Item Name: Crosstube Mid Fwd, Blue

DRAWING NO. D206-667-147  
REV. A  
SHEET 1 OF 4

DRAWING NO. D206-667-147	TITLE CROSSTUBE ASS'Y (206L MID FWD)	REV. A	<b>DART AEROSPACE LTD ENGINEERING ORDER</b>		D.E.O. NO. D206-667-147-A-1	SHEET NO. SHEET 1 OF 1	SCALE NTS
DRAWN <i>q</i>	CHECKED <i>ASS</i>	MFG. APPR. <i>JB</i>	APPROVED <i>MD</i>		DE APPR. <i>MD</i>		
DATE 11.07.15	DATE 11.07.20	DATE 11.07.21	DATE 11/07/21		DATE 11.07.21

DRAWING NO. D206-667-147	TITLE CROSSTUBE ASS'Y (206L MID FWD)	REV. A	DART AEROSPACE LTD ENGINEERING ORDER	D.E.O. NO. D206-667-147-A-2	SHEET NO. SHEET 1 OF 1	SCALE NTS
DRAWN AJ S	CHECKED	MFG. APPR.	APPROVED	DE APPR.		
DATE 12.08.02	DATE 12.08.02	DATE 12.08.02	DATE 12.08.02	DATE 12.08.02	DATE 12.08.02

**DETAIL P**  
BONDING STRAP INSTALLATION 2 PL

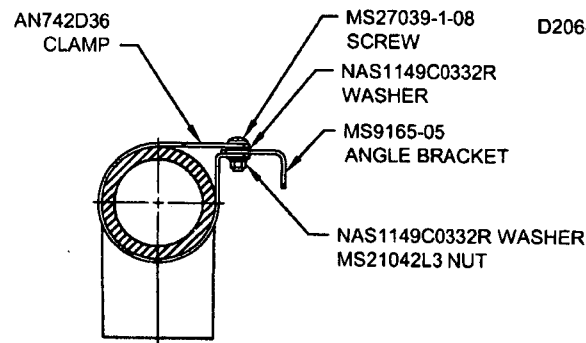
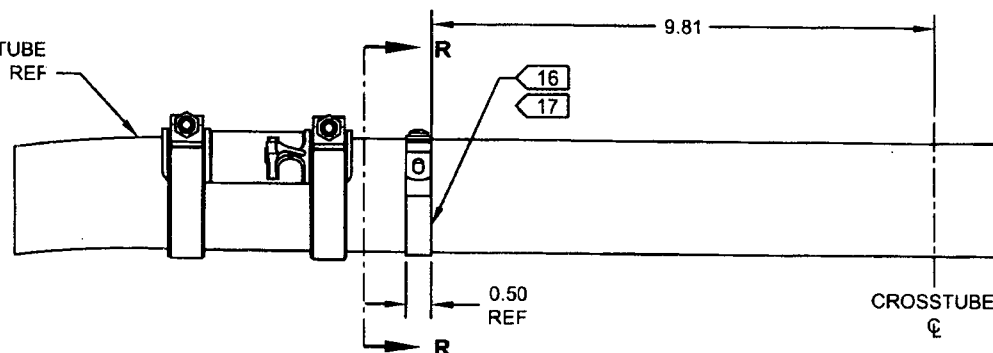
ADD ELECTRICAL GROUNDING STRAP

- 16) MASK AREA UNDER CLAMP PRIOR TO PAINTING
- 17) SEAL EDGES WHERE AN742D36 CLAMP MEETS WITH THE CROSSTUBE USING SIKAFLEX-241/-291 OR MIL-S-8802 CLASS B2 OR PROSEAL 890 SEALANT
- 18) PERFORM RESISTANCE CHECK TO ENSURE MAX RESISTANCE IS 10 MILLIOHMS

QC15 Inspection	
Date

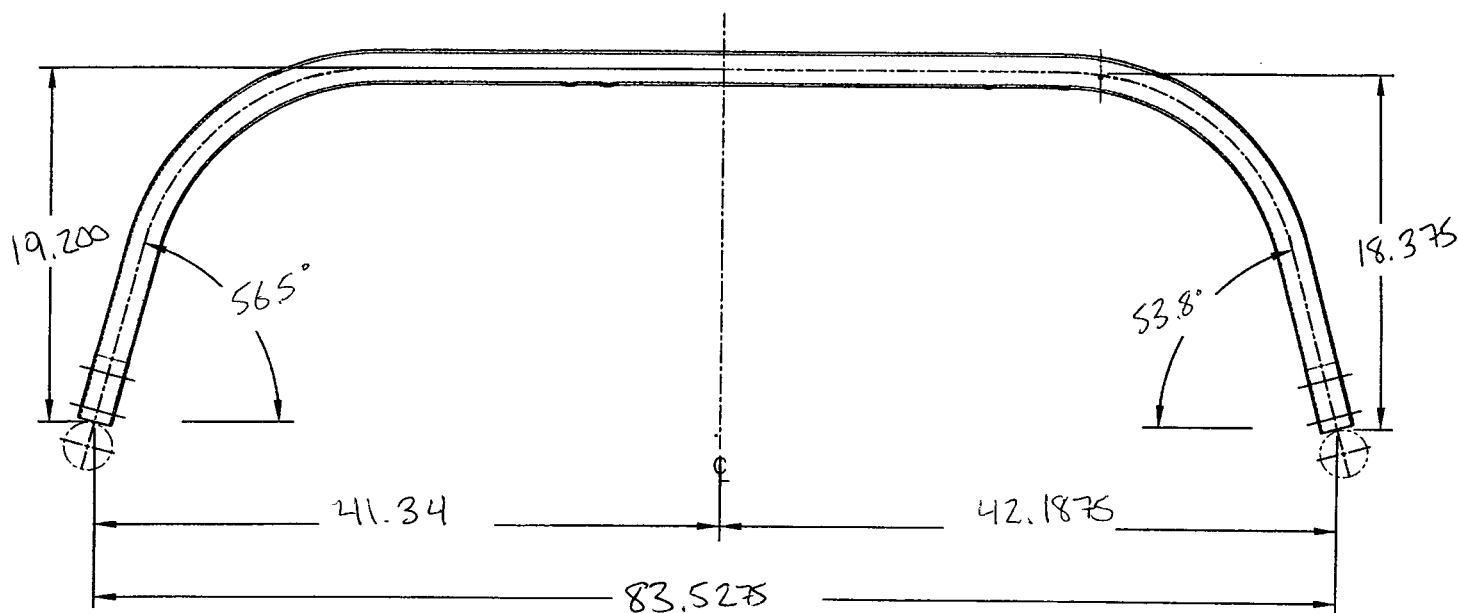
Side A	Side B
<b>Bending Passes</b>		
<b>Crushing</b>		
<b>Comments</b>		
Too narrow, SCRAP 4/12/19/24
